**ORDINARY MEETING
OF COUNCIL**

**AGENDA
OPEN MEETING
25 JUNE2018**

**Item 7.3
Supporting Documents
SD 1970 – 263 Port Road Boat Harbour Beach**

Application for Planning Permit
Proposed Subdivision
In the
LOW DENSITY RESIDENTIAL ZONE
263 Port Road, Boat Harbour

CLIENT Gerd Hagmaier	PID: 2750112	DRAWN BY M Wells	SCALE @ A3 1: 600	DESIGNERS DESCRIPTION: EnviroPlan	DESCRIPTION Bushfire Hazard Management Plan
PROJECT 263 Port Road, Boart Harbour	CT: 148990/o	ISSUE 10/05/2018		DESIGNERS REFERENCE NUMBERS: AO.1

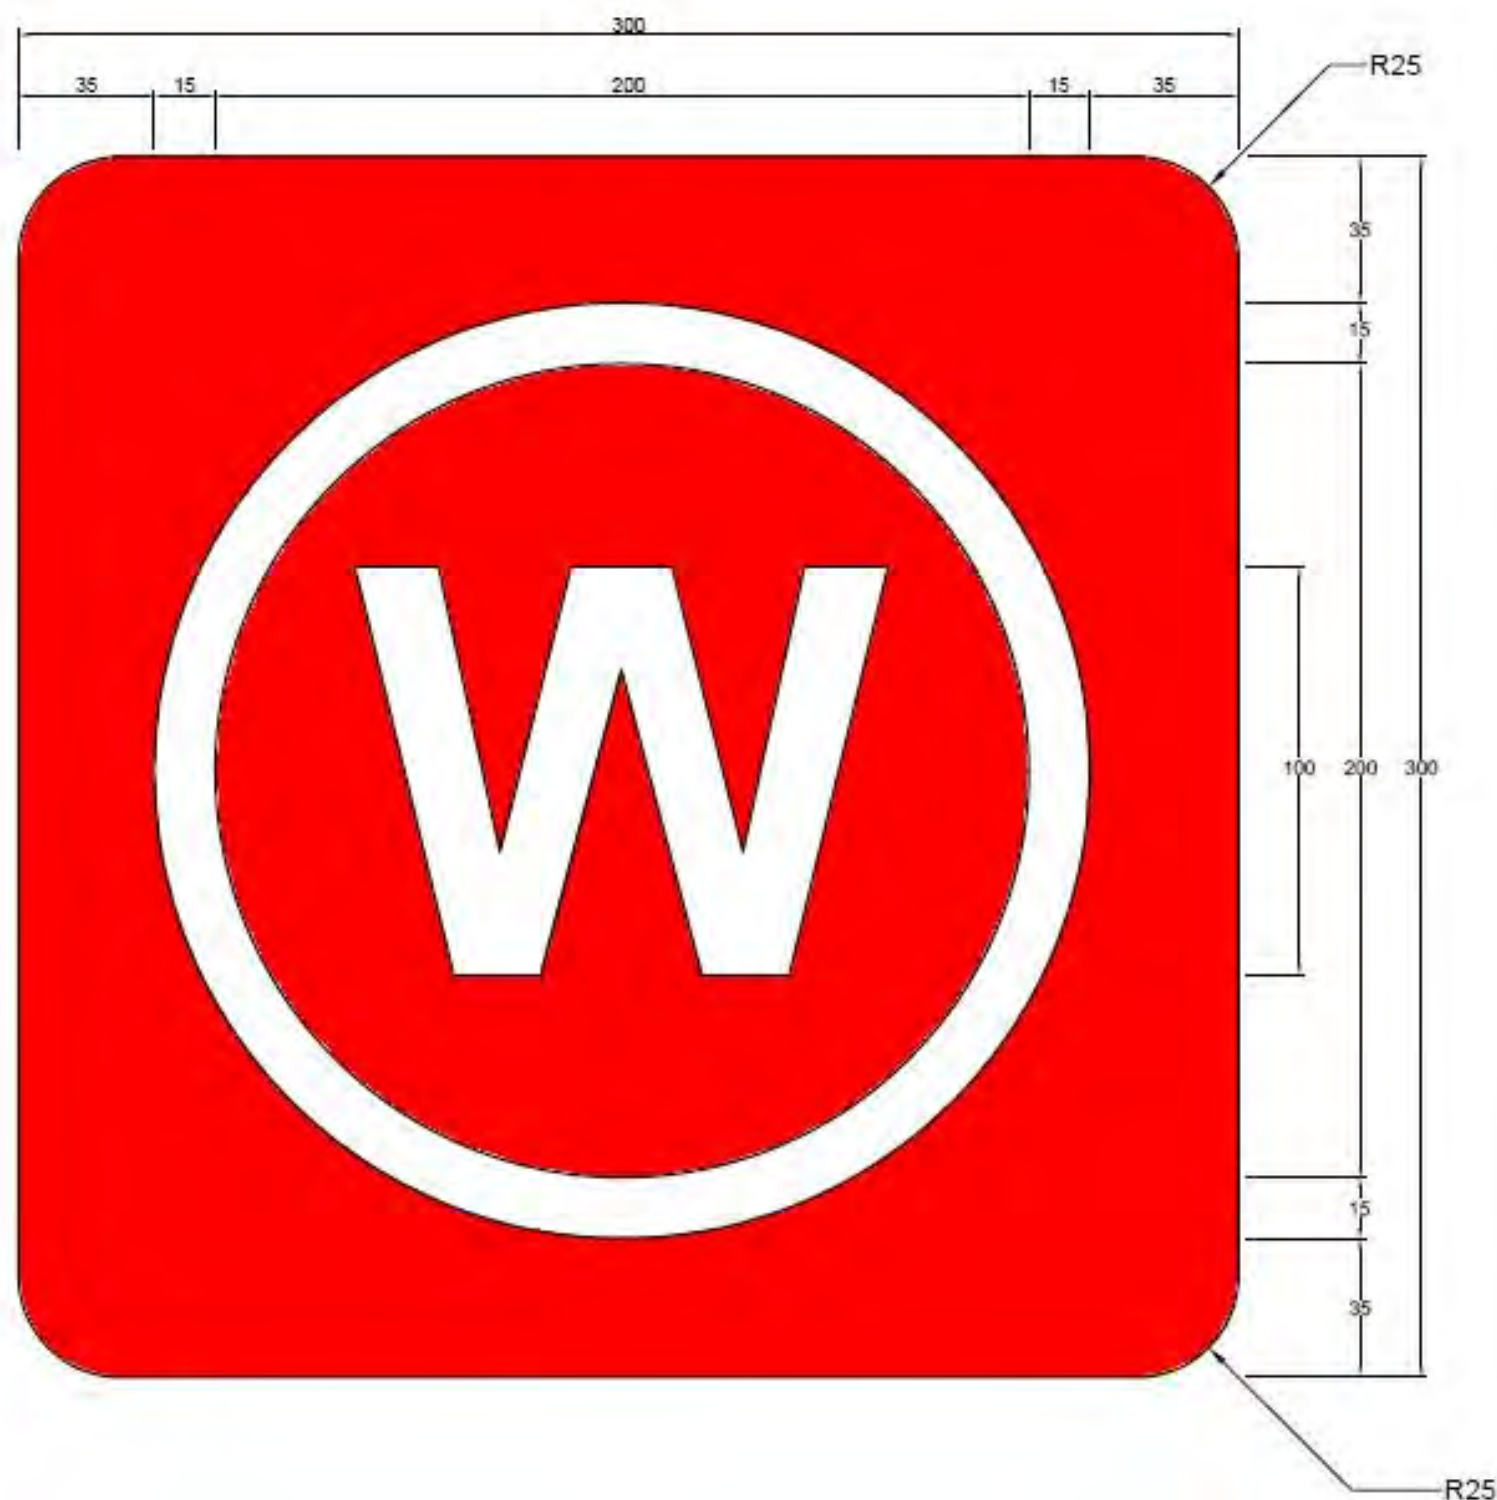
9. ***Demonstration of compliance with clause E9.5.1 Provision of parking of the Waratah-Wynyard Interim Planning Scheme 2013. Please provide details on remaining dwellings to demonstrate compliance with clause, how many spaces will be provided on-site within the proposed boundary arrangements and locations of these.***

Please refer to revised Drawing A0.1 from EnviroPlan drawn at a scale of 1:1000 @ A3.

Please refer to revised drawing A0.1 drawn by EnviroPlan. This demonstrates 2 car parking spaces per dwelling site with exception to lot 8 where 4 spaces are provided on a Strata lot of the 2 units.

drawn	DG	 TASMAN geotechnics	client:	Gerd Hagmaler	
approved	WG		project:	Landslide Risk Assessment 263 Port Road, Boat Harbour	
date	14/03/2018		title:	MRT Landslide Susceptibility	
scale	NTS		project no:	TG18061/1 – 01report	figure no: FIGURE 3
original size	A4

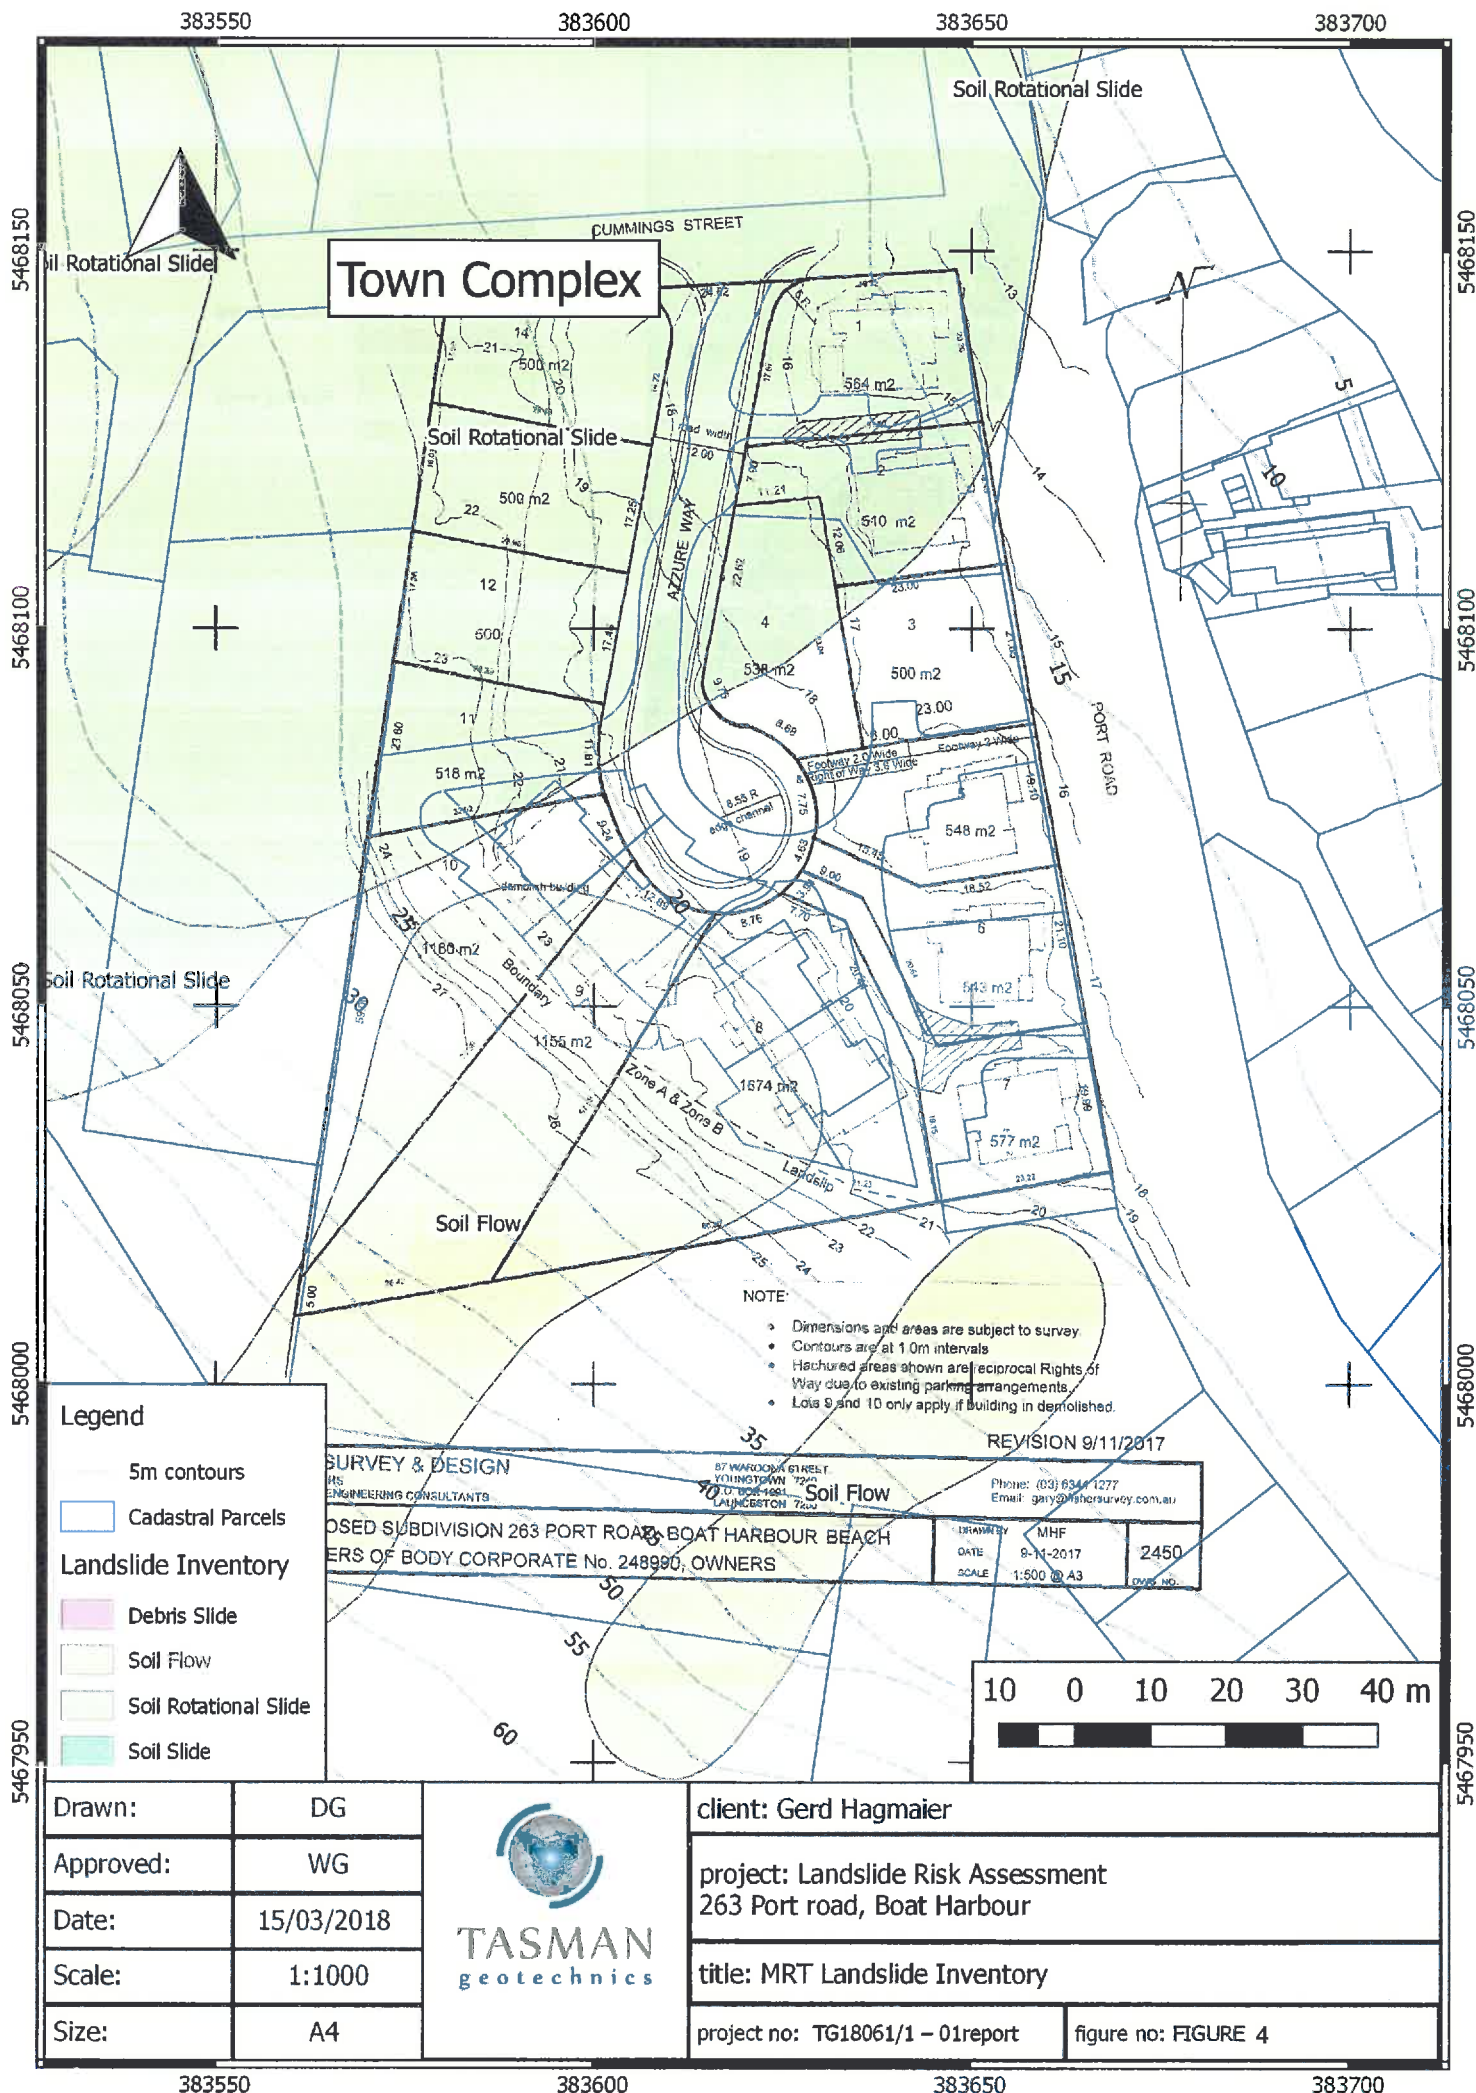
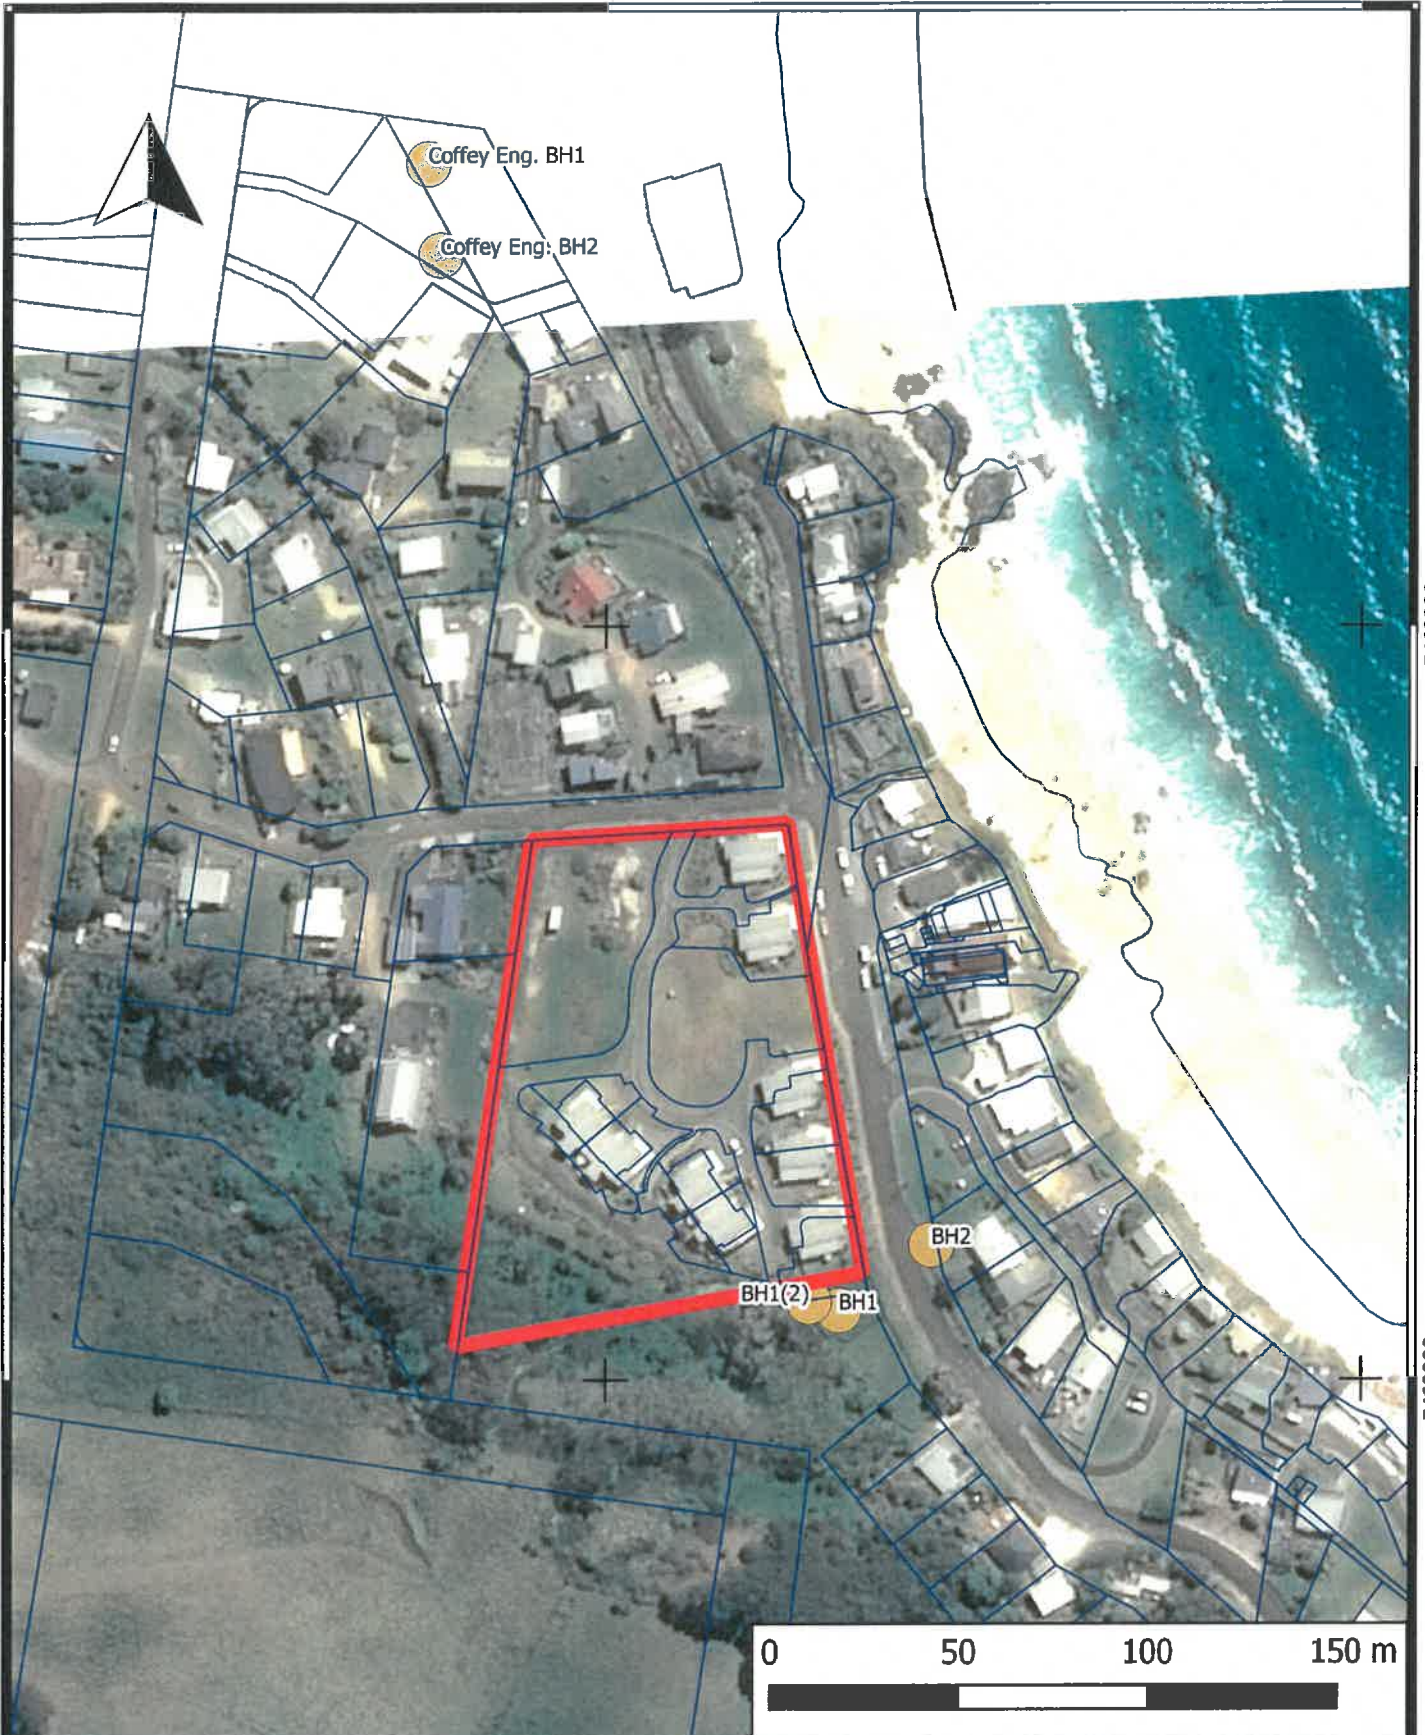
- A Geotechnical Risk Assessment that considers the proposed subdivision application as submitted. The report provided highlights 251 Port Road Boat Harbour Beach. Refer to Figure 3, 4 and 5 of the report. Therefore the Geotechnical Risk Assessment

7. A geotechnical Risk Assessment that considered the proposed subdivision application as submitted. The report provided highlights 251 Port Road Boat Harbour Beach. Refer to Figure 3, 4 and 5 of the report. Therefore the Geotechnical Risk Assessment has not demonstrated that the proposal will have a tolerable level of risk for all new lots in order to comply with Hazard Management Code of the Waratah-Wynyard Interim Planning Scheme 2013.
